ZONING ADMINISTRATOR MEETING AGENDA

PUBLIC HEARING**2. SC24-0006 – Narinder Paul – 1501 Oakley Drive**

SUBMITTAL OF PLANNING APPROVAL FOR
PAUL RESIDENCE
1501 OAKLEY DRIVE
LOS ALTOS, CA 94024
APN:318-10-025

NEW SITE PLAN WITH
BASEMENT FLOOR

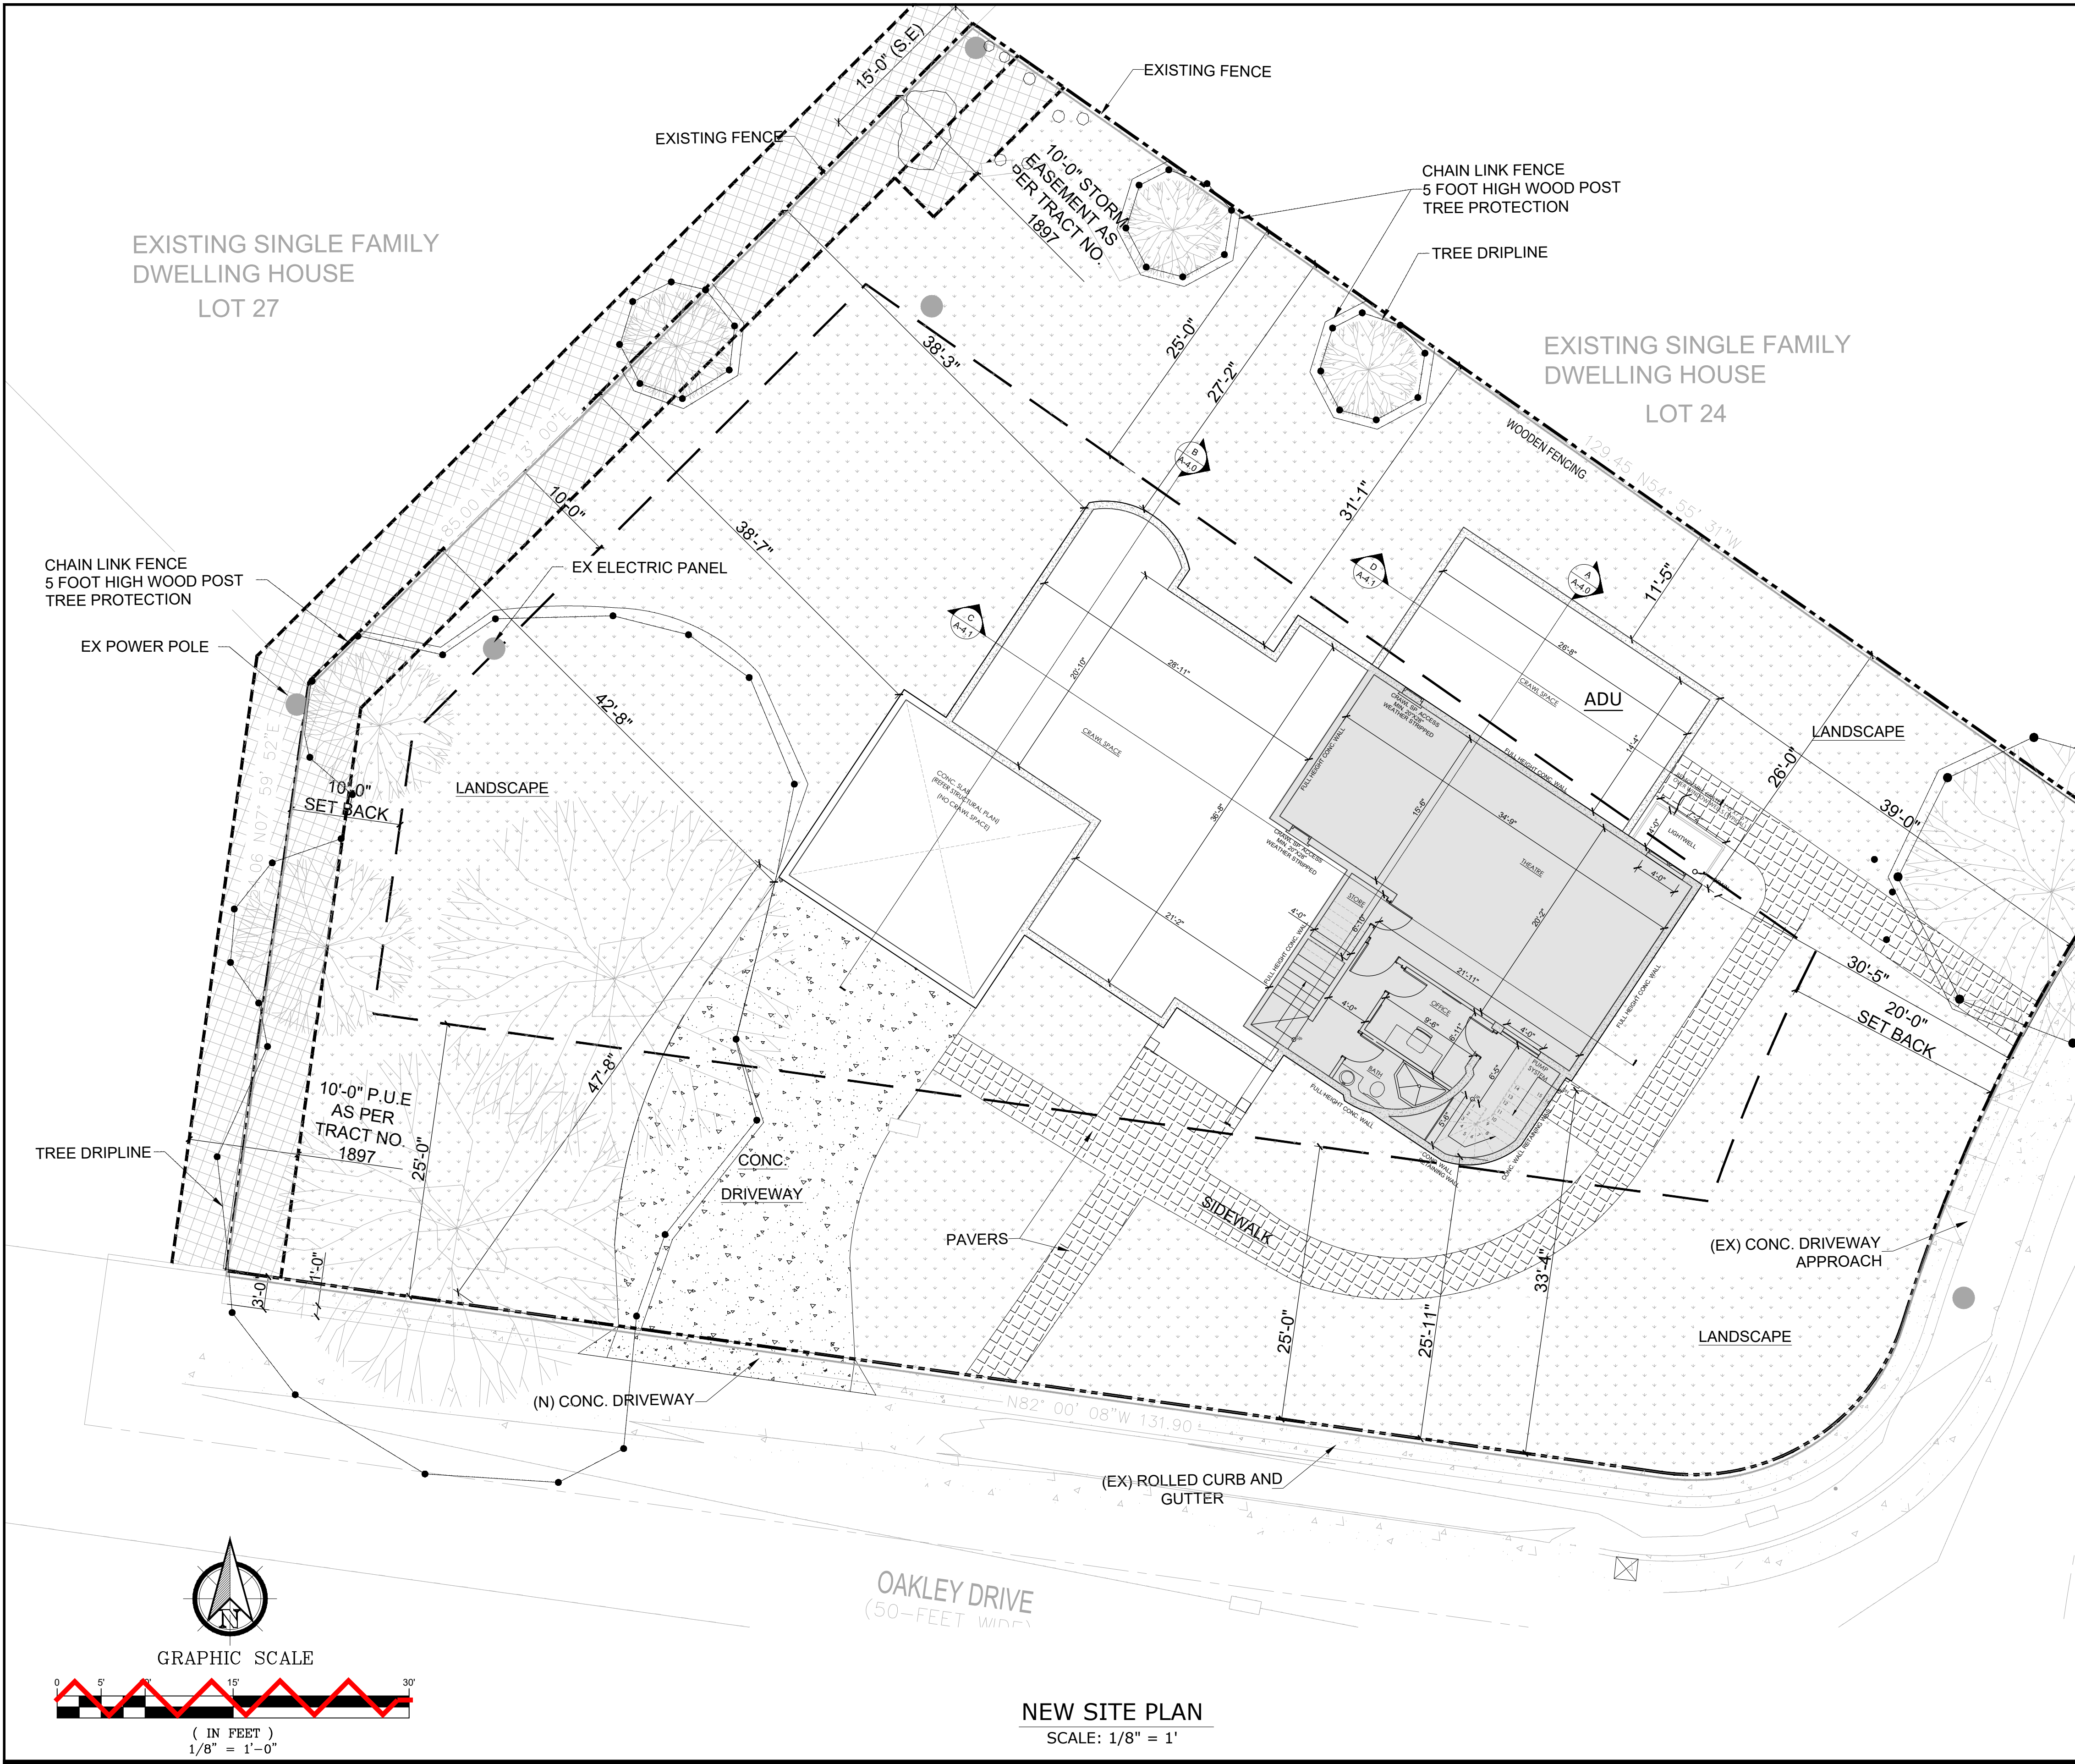
- a. On C-4.0-C-4.2 remove or correct the scale bars indicating 10 scale.
 - b. On the Basement Site Plan add dimensions to indicate the basement exterior facade lengths and demonstrate light well widths comply or revise the plans as necessary to reduce the width for compliance.

LEFT ELEVATION

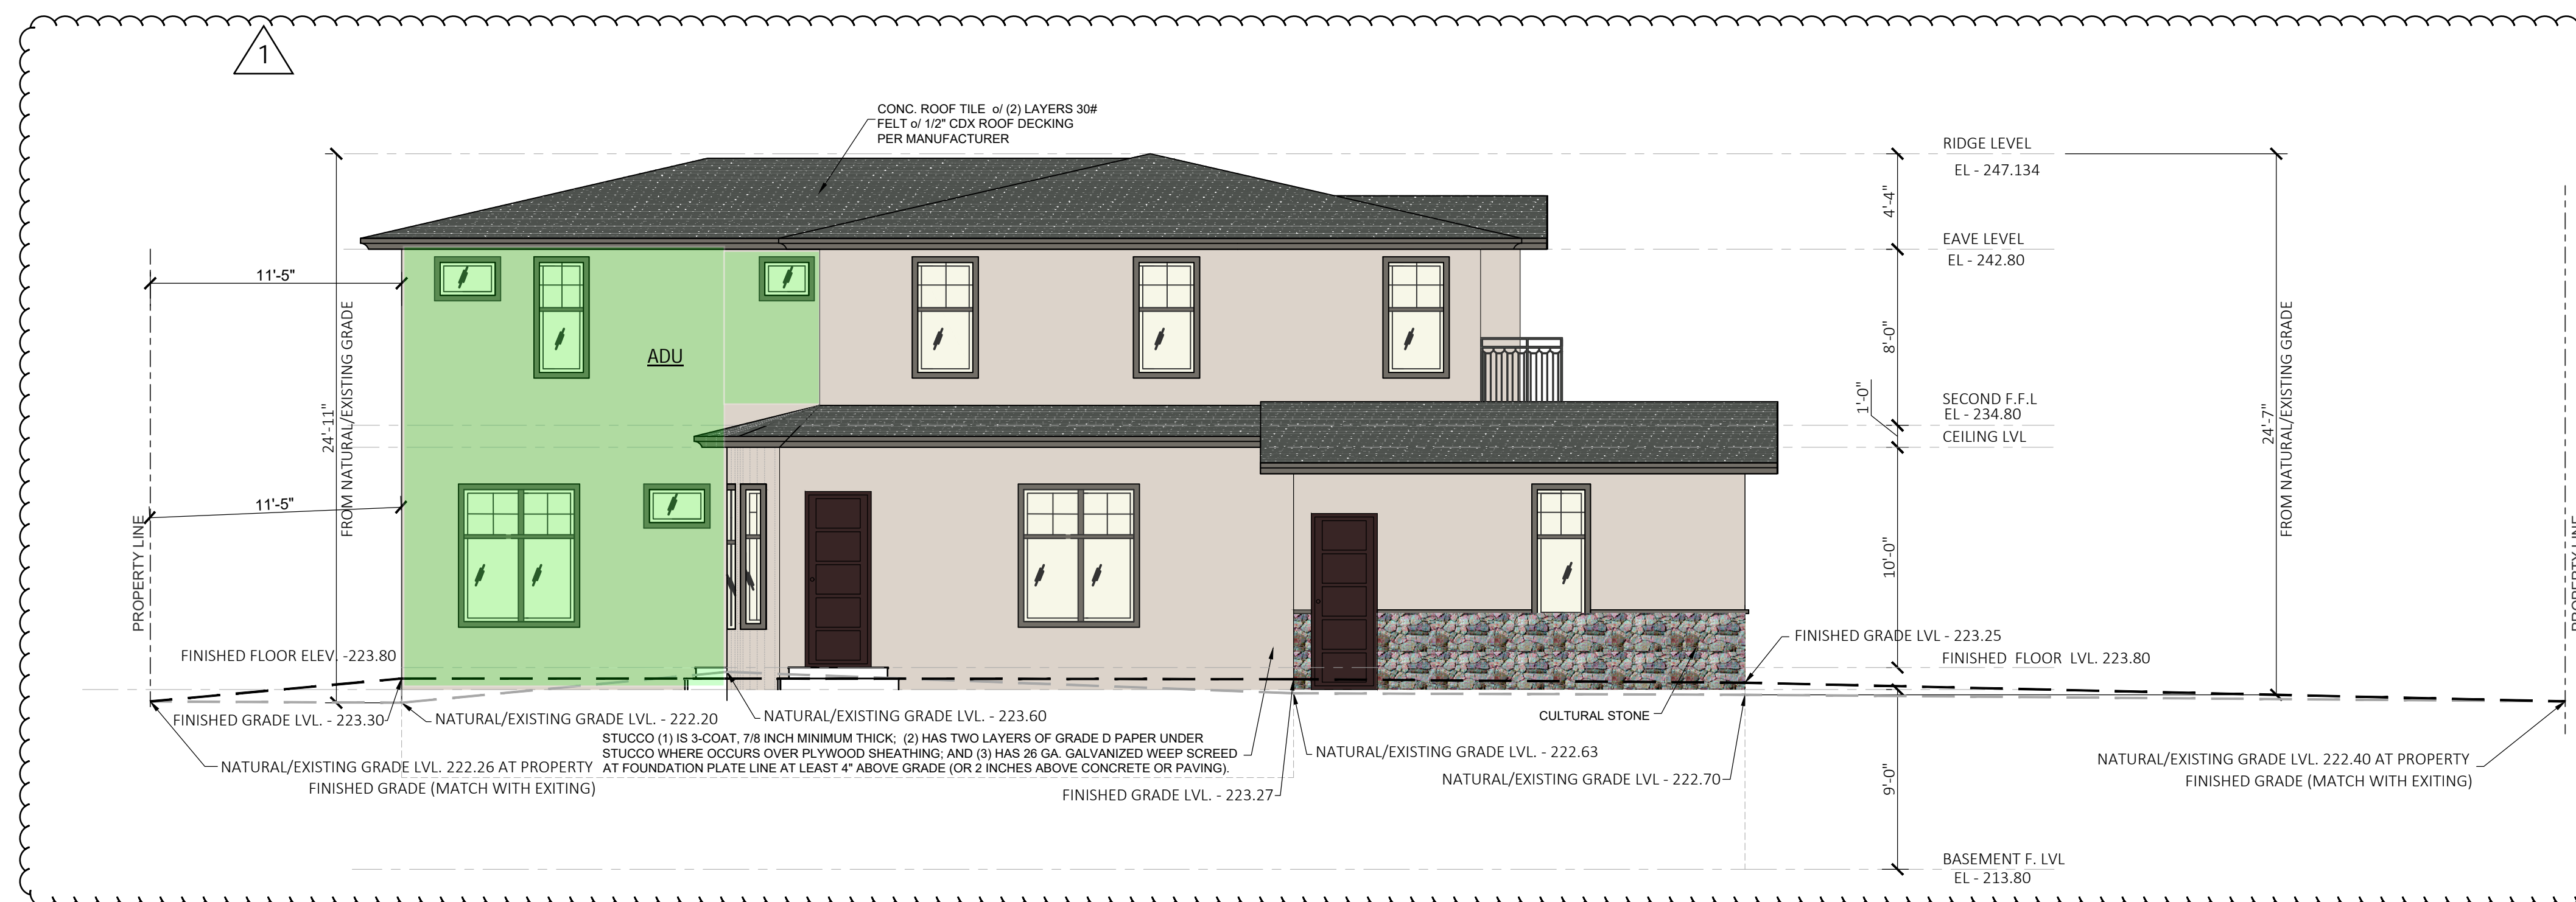
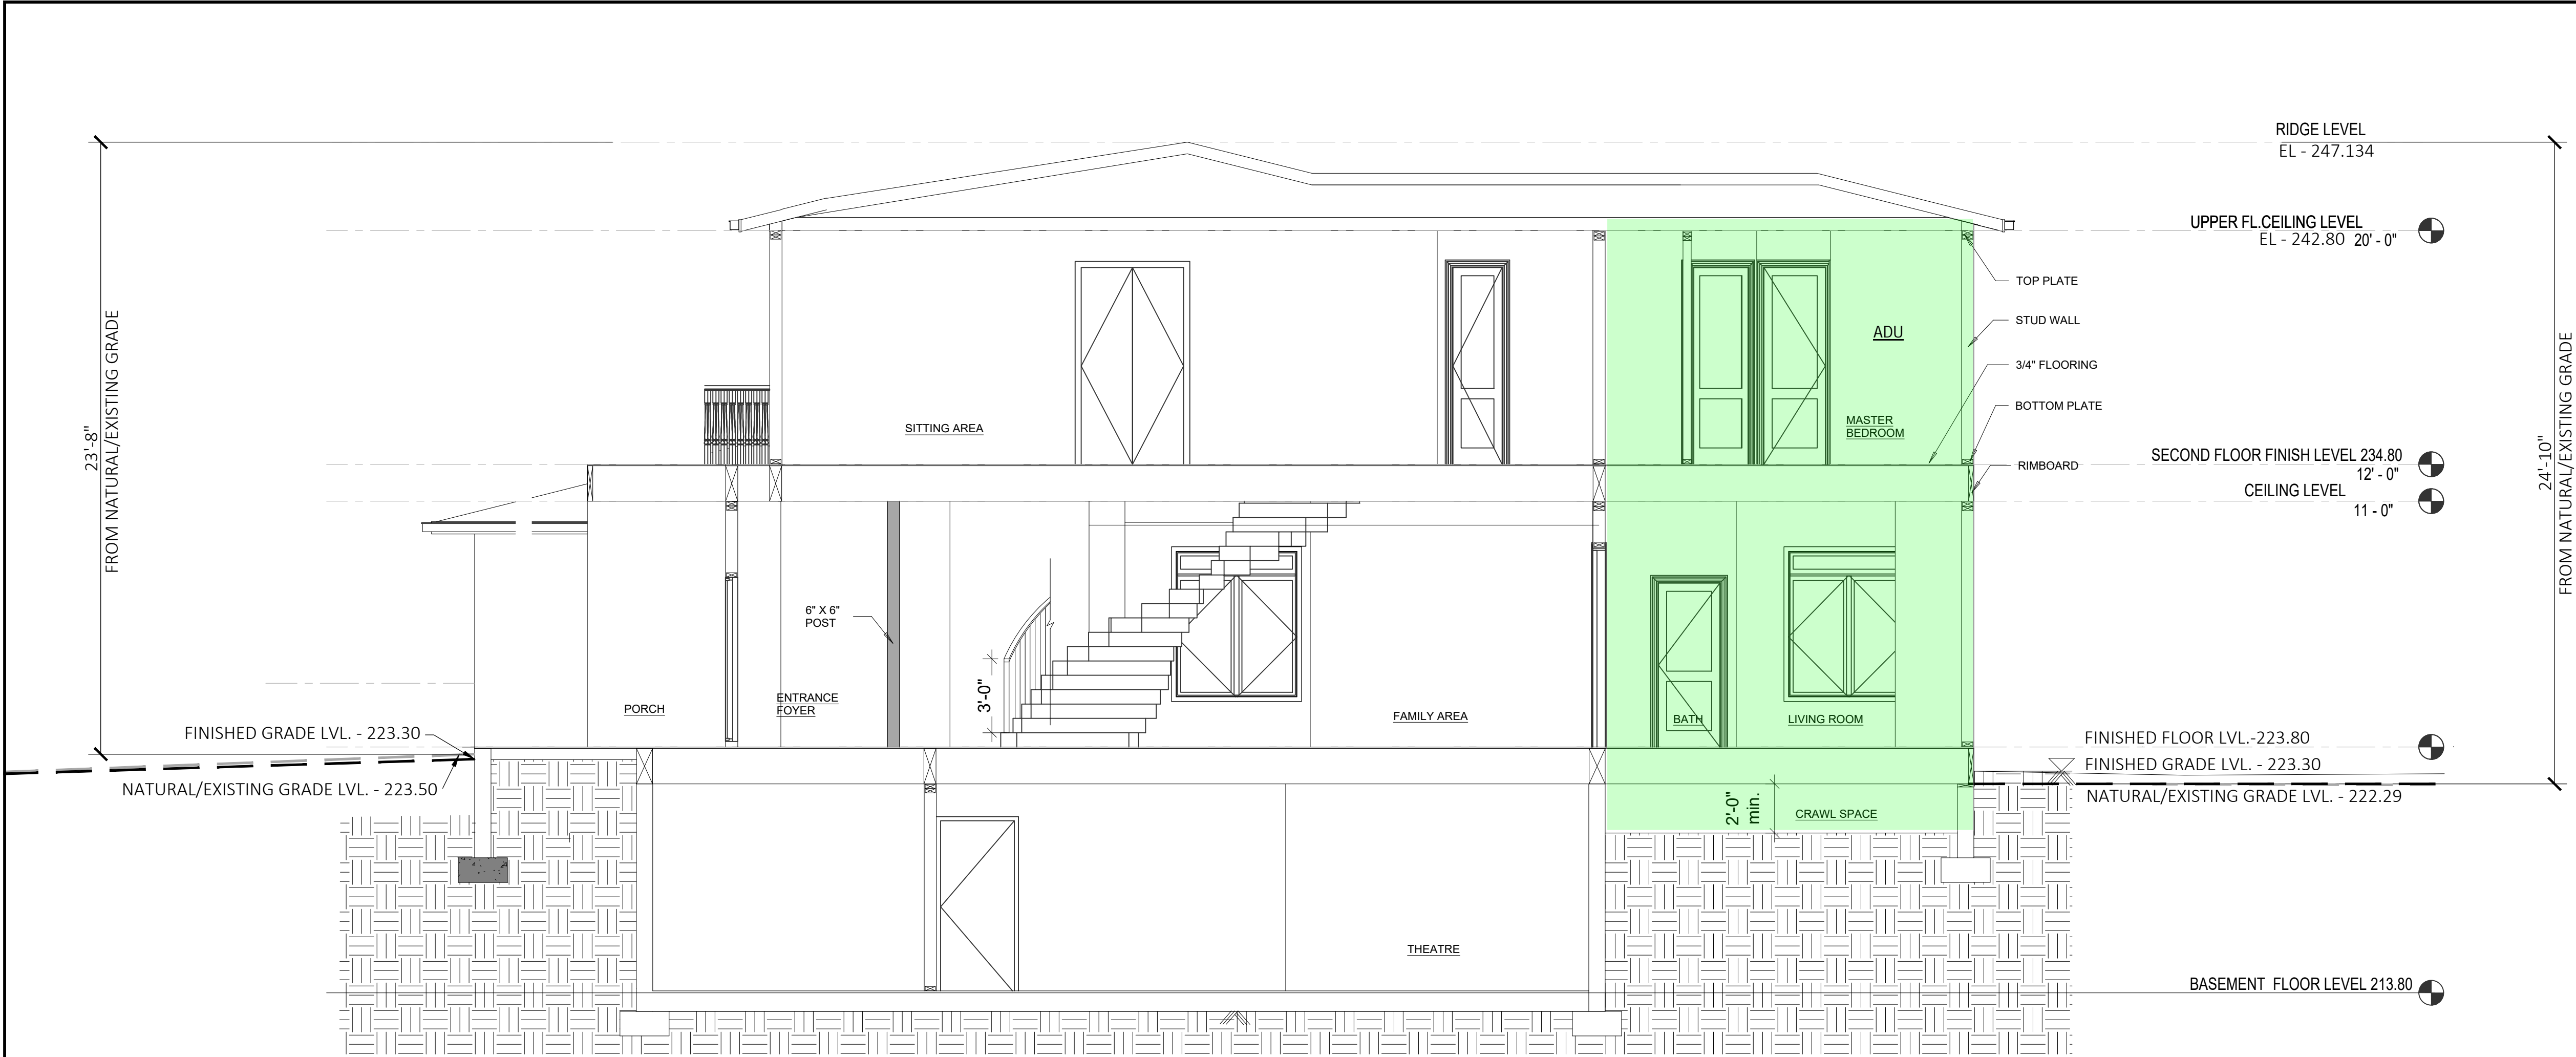
- c. On the Elevation Drawings:
 - i. Correct the labels for the side elevations to indicate Right Elevation for the ADU entry/street side and Left Elevation for the garage side.

- ii. Revise the wainscoting depicted on the elevations to match the Cover Sheet rendering.
